# CITY OF ALBUQUERQUE

**RE: 3601 Seven Bar Loop Rd NW**  
**Grading and Drainage Plan**  
**Engineer's Stamp Date: 02/26/2026**  
**Hydrology File: B14D019**  
**Case # HYDR-2026-00074**

Based upon the information provided in your submittal received 02/27/2026, the Grading and Drainage Plan **is not approved** for Grading Permit and Building Permit. The following comments need to be addressed for approval of the above referenced project.

ENGINEER'S SEAL	STORAGE FACILITY 7 BAR LOOP, ALBUQUERQUE, NM	DRAWN BY BF
	DATE 02/26/2025	DRAINAGE PLAN FOR INFO ONLY	2024014_BASINS
		TERRA WEST, LLC 5571 MIDWAY PARK PLACE NE ALBUQUERQUE, NM 87109 (505) 858-3100 www.terrawestllc.com	SHEET # GR-0
RONALD R. BOHANNAN P.E. #7868			JOB # 2024014

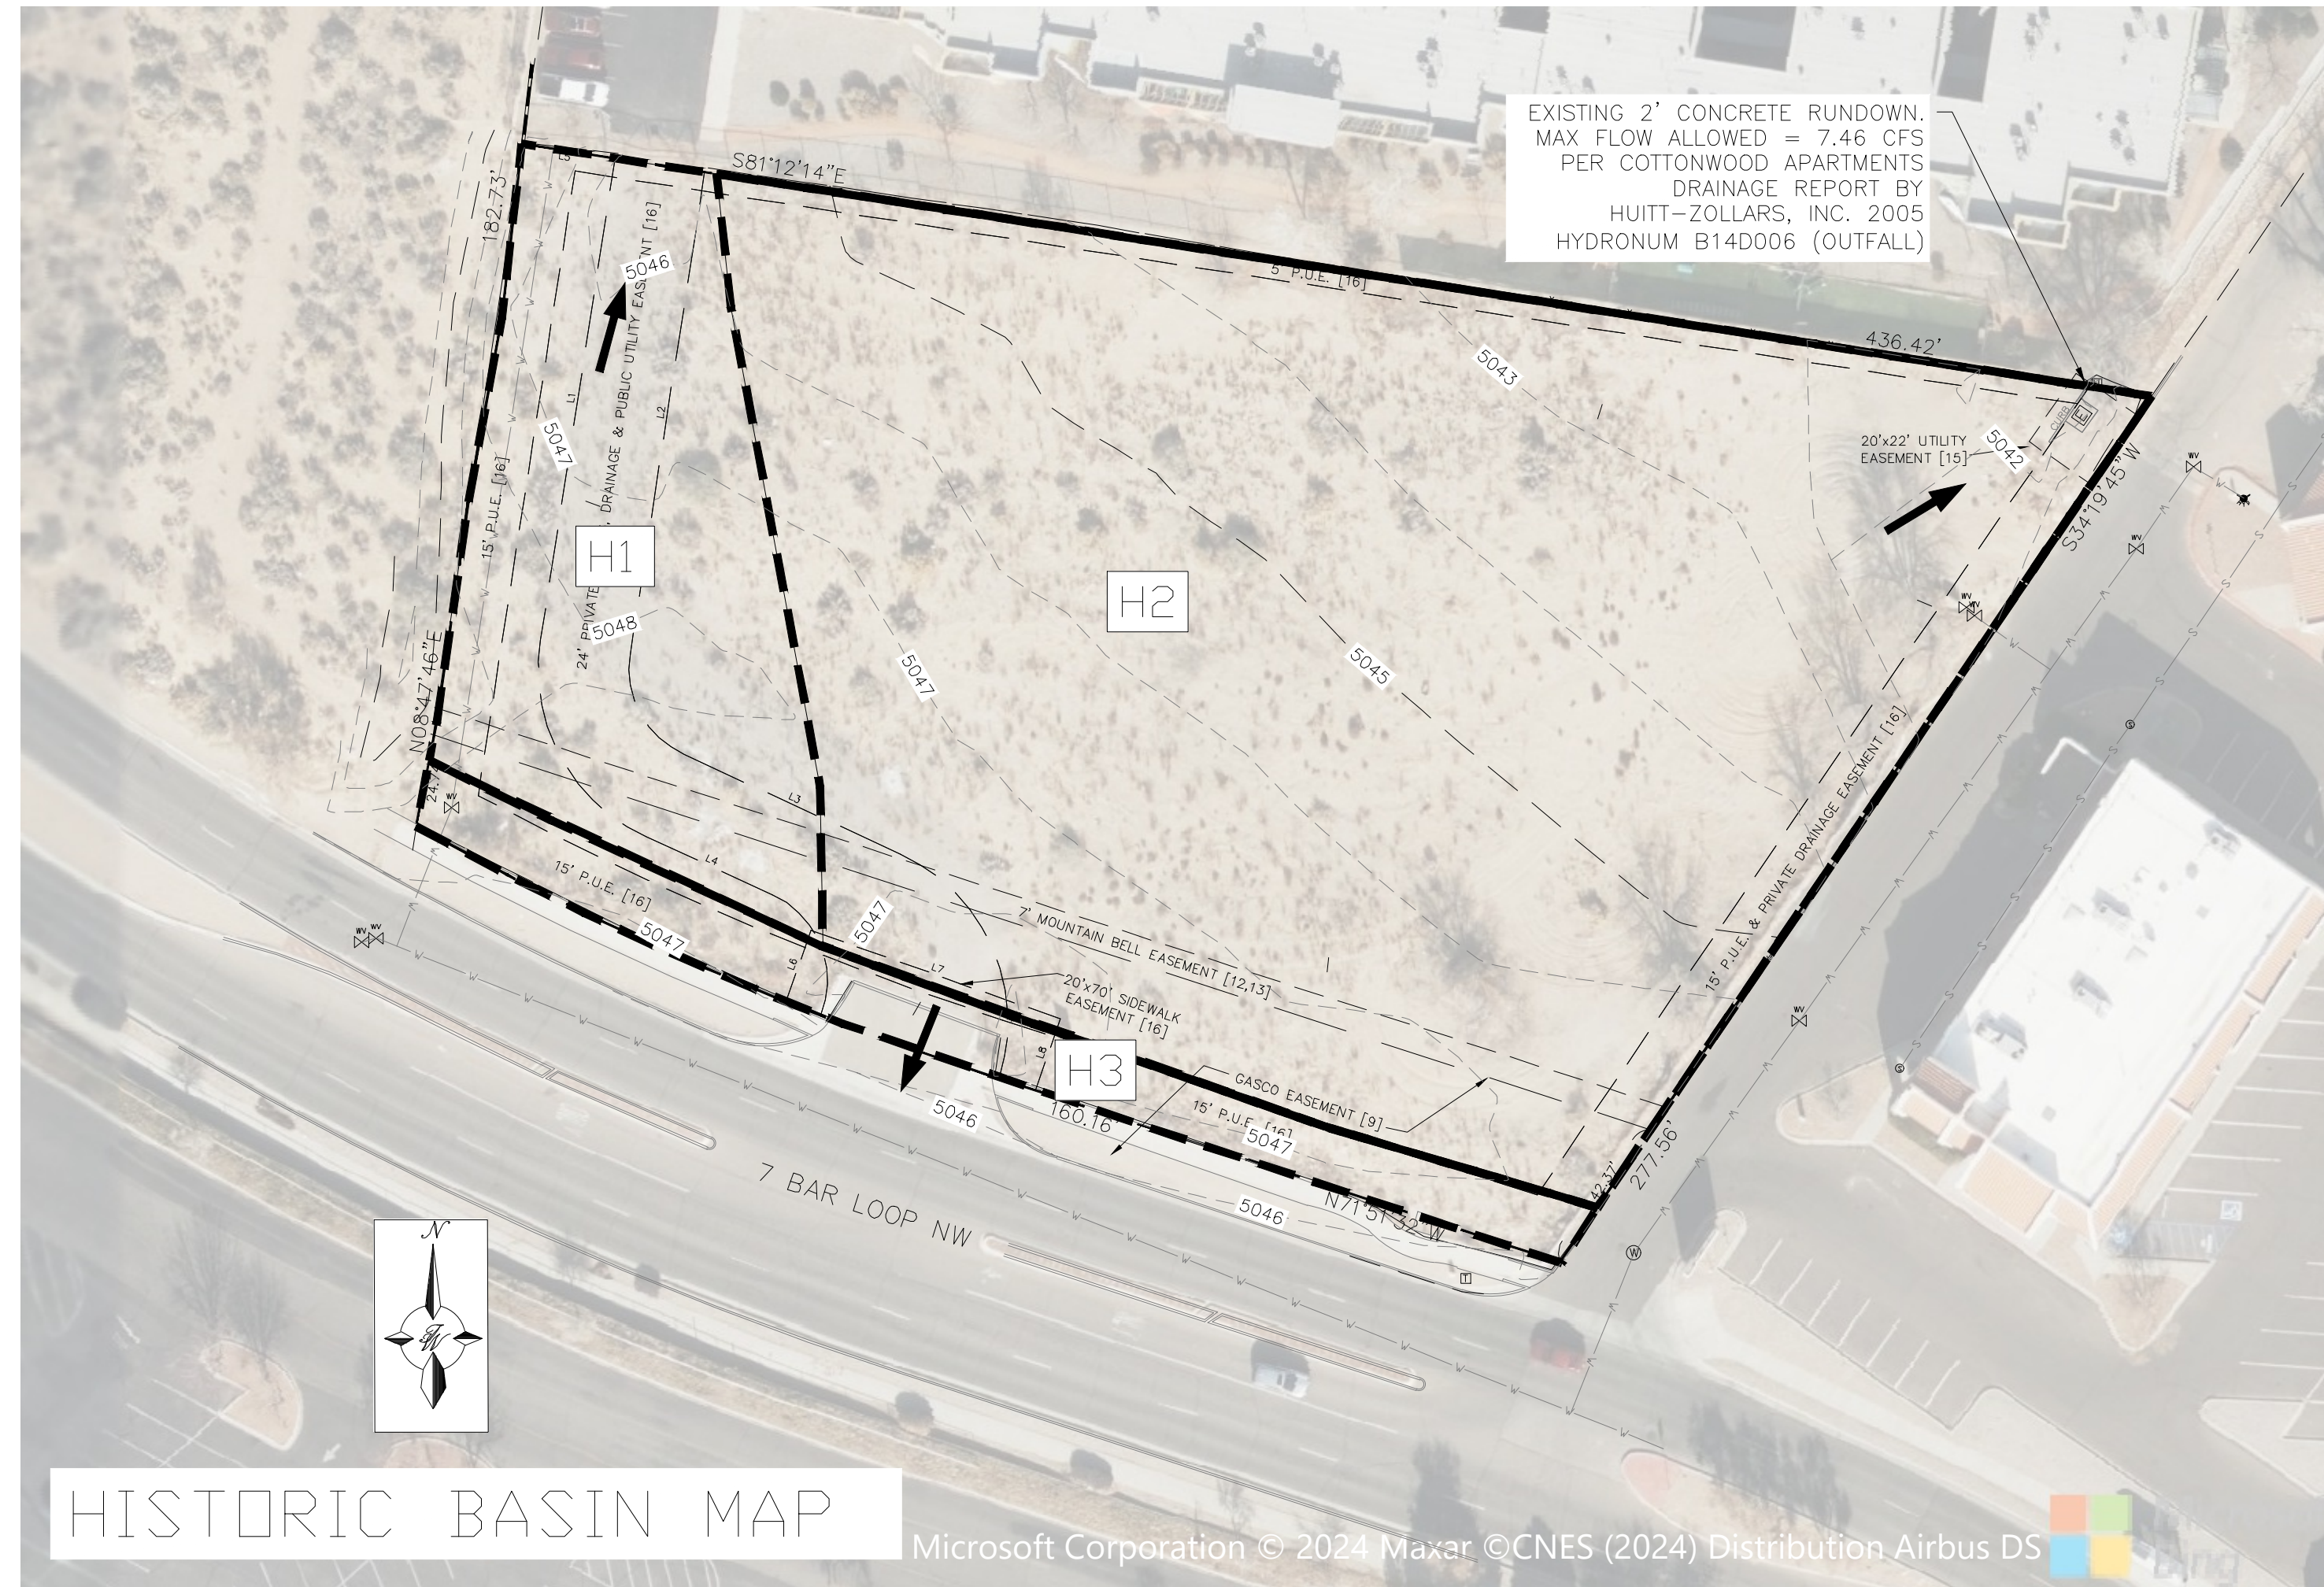
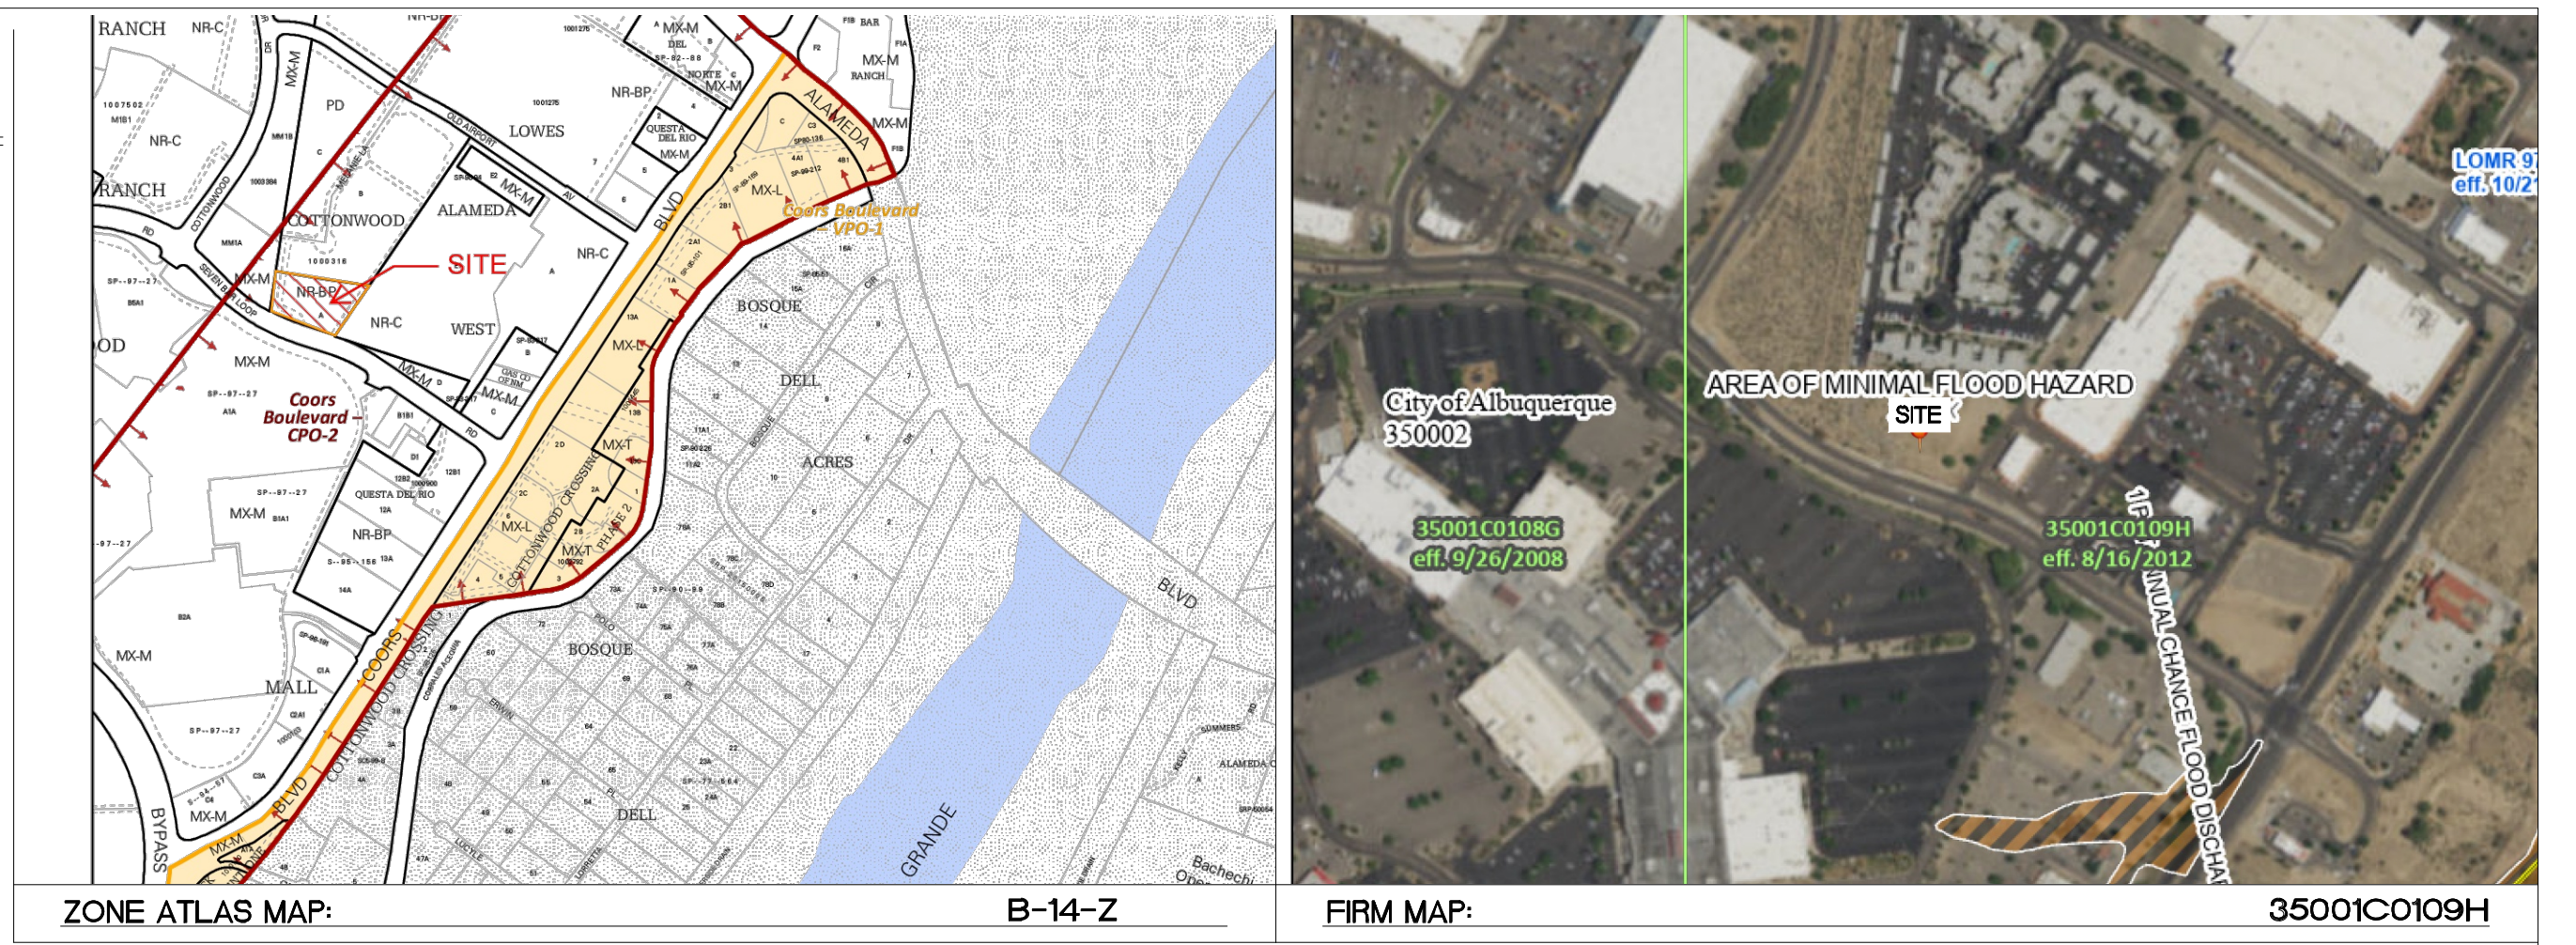
Existing Conditions		Basin Descriptions										100-Year, 6-Hr			
Basin ID	Tract	Area (sf)	Area (acres)	Area (sq miles)	Treatment A		Treatment B		Treatment C		Treatment D		Weighted E (in)	Volume (ac-ft)	Flow (cfs)
					%	(acres)	%	(acres)	%	(acres)	%	(acres)			
H1	A	14,580	0.33	0.00052	40%	0.134	0%	0.000	60%	0.201	0%	0.000	0.790	0.022	0.78
H2	A	65,011	1.49	0.00233	80%	1.194	0%	0.000	20%	0.298	0%	0.000	0.630	0.078	2.70
H3	A	5,492	0.13	0.00020	70%	0.088	5%	0.006	20%	0.025	10%	0.013	0.836	0.009	0.27
<b>Total</b>		<b>85,083</b>	<b>1.95</b>	<b>0.00305</b>		<b>1.416</b>		<b>0.006</b>		<b>0.525</b>		<b>0.013</b>		<b>0.109</b>	<b>3.75</b>

ENGINEER'S SEAL  RONALD R. BOHANNAN P.E. #7868	<b>STORAGE FACILITY 7 BAR LOOP, ALBUQUERQUE, NM</b>	DRAWN BY BF
	<b>GRADING &amp; DRAINAGE PLAN</b>	DATE 02/26/2025
TIERRA WEST, LLC 5571 MIDWAY PARK PLACE NE ALBUQUERQUE, NM 87109 (505) 858-3100 www.tierrowestllc.com	SHEET # <b>GR-1</b>	JOB # 2024014

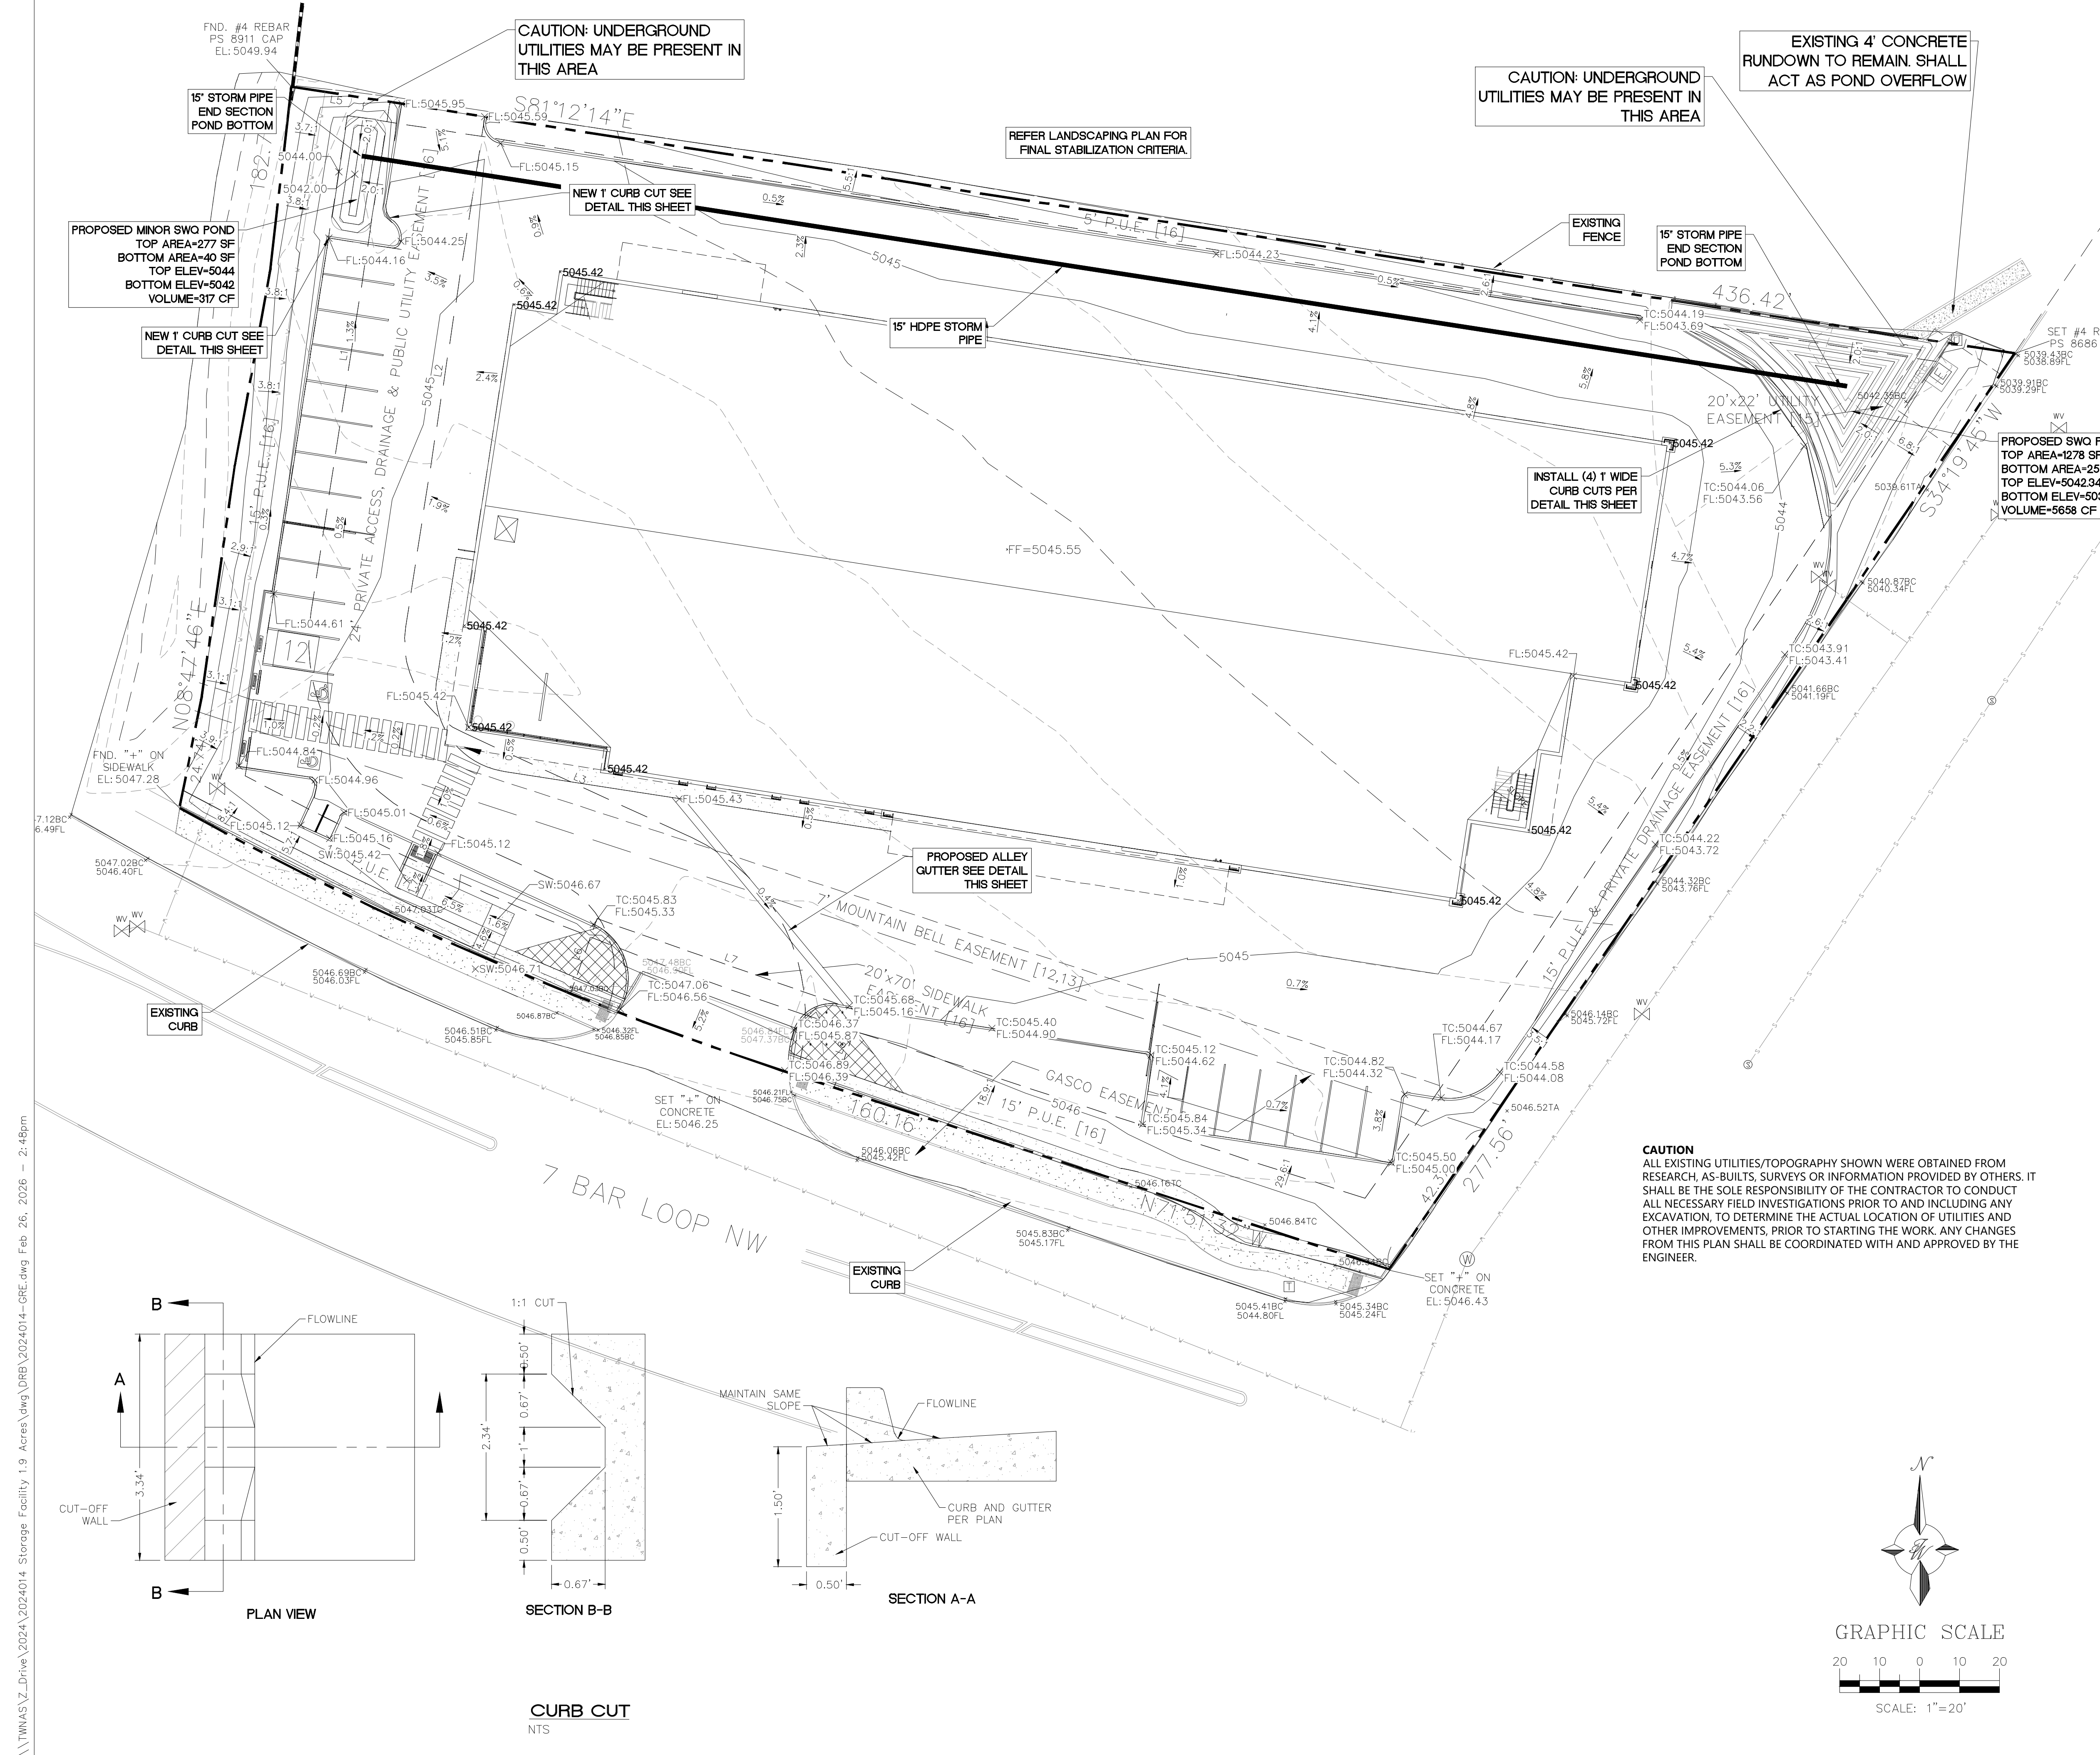
1. Please provide the legal description of the property.
2. Please provide the Benchmark information (location, description and elevation) for the survey contour information provided.
3. Show finished floor and finished pad elevations for all structures.
4. Please make sure treatment areas add up to 100%
